# NEWMAR CORPORATION

# TECHNICAL SERVICE BULLETIN

DATE ISSUED	MODEL YEAR(S) AFFECTED	TSB #
5/26/2017	2017	480

Spartan Motors USA, Inc. has decided that a condition exists where the power steering pumps may be equipped with an incorrectly sized orifice. Spartan Motors USA, Inc. made the decision to issue a Campaign Service Bulletin, **CSB17-260-001**, for certain 2017 model year K2 motor home chassis built between August 22, 2016, and October 5, 2016. In response, Newmar Corporation is publishing TSB 480.

FIG. 2-1

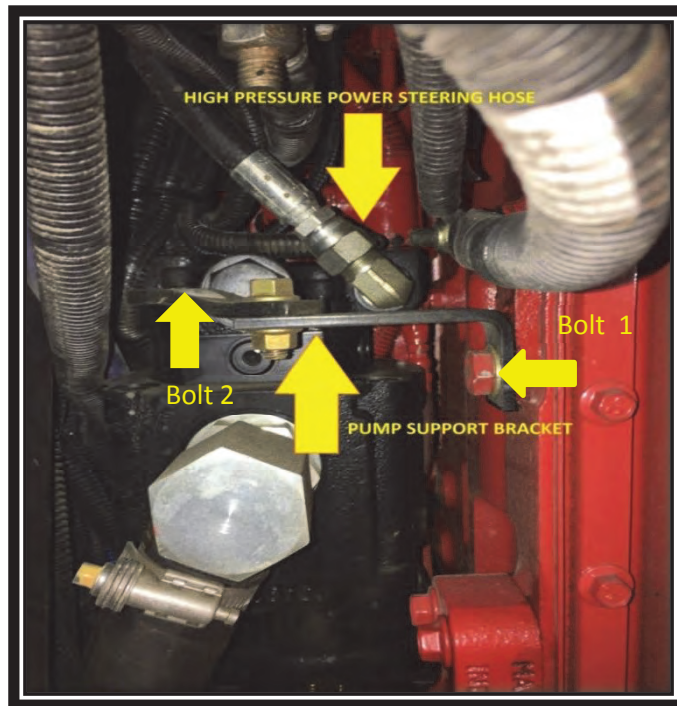
1. Remove the power steering pump support bracket from the pump & the engine block by removing bolts 1 & 2, allowing access to the hex head cover as viewed from bottom. Retain for re-use. Refer to FIG. 2-1

FIG. 3-1

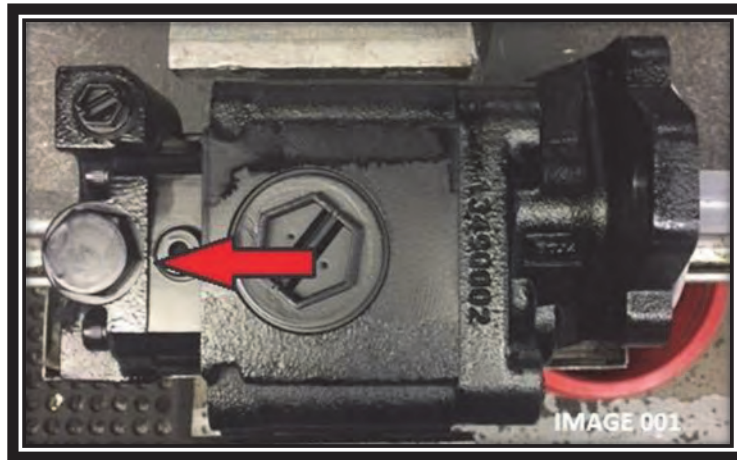
2. Clean lower surface areas on pump with any available degreasing product to ensure that the pump is not susceptible to contamination once opened.
3. Install the 30mm socket on the hex head cover and remove the cover shown. NOTE: The cover will be under a slight spring pressure. Refer to FIG. 3-1.

FIG. 3-2

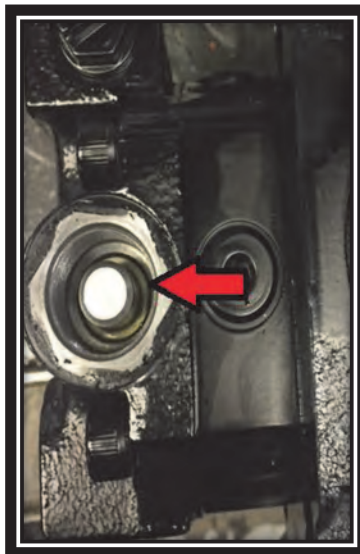
4. Once the cover is removed you will have exposed both the spool and spring. Remove the spring and place in a clean, dry location. Retain for re-use. NOTE: Some oil will drain from this location upon removal of the cap. Be prepared as the spool may slide out on its' own due to gravity. Refer to FIG. 3-2.

FIG. 4-2

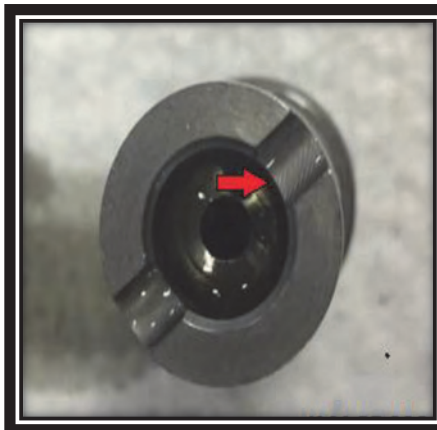
- Re-install retained hex head cover to minimize oil loss. This can be hand tightened.
- Once the spool is removed, flip it over to expose the snap ring. Using the snap ring pliers remove the snap ring. Refer to FIG. 4-2 and FIG. 4-3.

FIG. 6-1

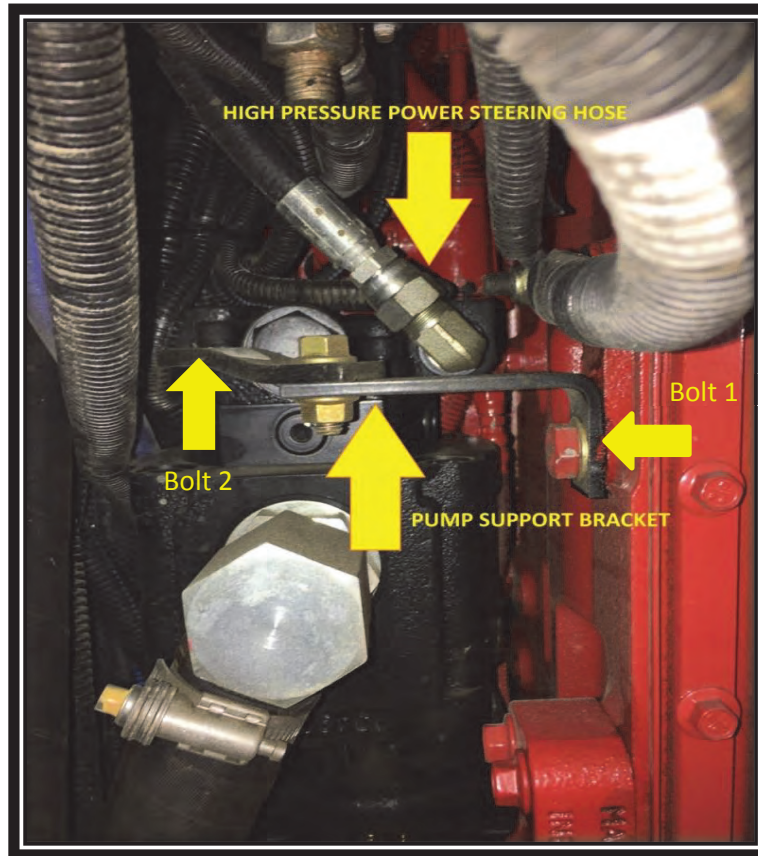
8. With the snap ring removed, tap spool against palm of your hand to remove orifice disc. Note orientation of orifice in spool. Once removed, properly dispose of original orifice disc.
9. Remove certified orifice disc from packaging and install into the spool. Ensure that orientation is as per the original orifice disc.
10. Insert snap ring into the groove on the inside of the spool locking the orifice disc in place.  
**NOTE:** Use the snap ring pliers to spin the snap ring to ensure it is properly seated within the groove.
11. Remove hex head cover and insert spool into pump ensuring orifice disc is pointing away from you.
12. Replace the spring over top of the spool.
13. Reinstall hex head cover and torque to 90 NM (66.4 lbf-ft). Refer to FIG. 6-1.
14. Re-install retained pump support bracket to following specifications.

**NOTE: For the following instructions apply Loctite® 242® Thread locker to the bolt on the first five threads from end of bolt.**

- Bolt #1 – Tighten to 47 lbf- ft torque with **Loctite® 242®**.
- Bolt #2 – Tighten to 52 lbf- ft torque.
